Issue	**1**
Factory ID	**920037**
Date of Issue	**10-Jun-2026**

M/S Stylers International Ltd. - Unit 2 (Raiwind)

Electrical Safety Inspection Report

Pakistan Accord Initial Safety Inspection Report

Figure 2.9 - Hot spot found on the cable connector in the ETP distribution board

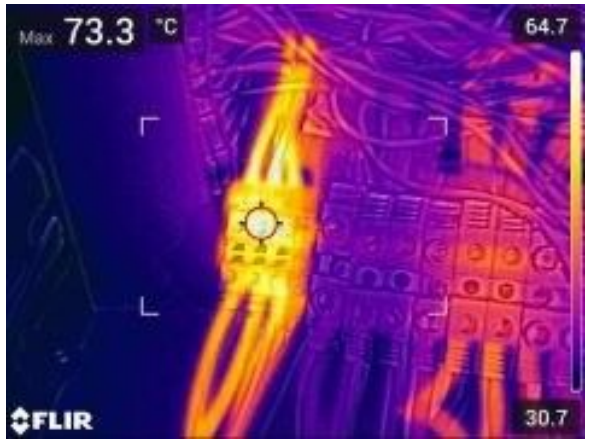
The categories of identified hot spots have been evaluated as per the ANSI NETA MTS 2019 standard, Table 100.18. Hot spots were observed, particularly at the following locations:
i. 85.8°C and 82.1°C at the busbar connection points, and 71.9°C on the base plate in the solar distribution board located on the rooftop of the main building.
ii. 73.7°C at the cable connector in the ETP distribution board.
iii. 61.1°C at the terminal block cable connection in the boiler distribution board.

Hot spots in electrical systems pose significant life safety risks due to several factors. Overheated components can ignite surrounding materials, leading to electrical fires. This is particularly dangerous in densely packed panels and distribution boards where flammable materials may be present. Hot spots can degrade insulation on wires and components, increasing the risk of electrical shock to personnel who might come into contact with exposed conductive parts. Overheating can contribute to conditions that might trigger an arc flash, a dangerous high-temperature

Timeline	Remediation Plan
Immediate CAP-0076462	Any circuits identified on site with temperatures exceeding 40°C above the ambient temperature, operating above 90°C or exhibiting visual signs of burning must be immediately isolated and taken out of service. These circuits should remain de-energized until a thorough review has been conducted and appropriate remedial actions have been implemented to resolve the underlying issues.
Medium Term CAP-0076463	During the inspection, several circuits were identified where the temperature was exceeding 20°C above ambient temperature, as illustrated in the example images below. It is recommended that the factory conducts comprehensive thermographic surveys of all electrical panels to detect similar issues. Identified hot spots should be thoroughly reviewed to determine their underlying causes. Corrective actions must be taken to address and resolve these issues, ensuring safe and reliable operation of the electrical systems.
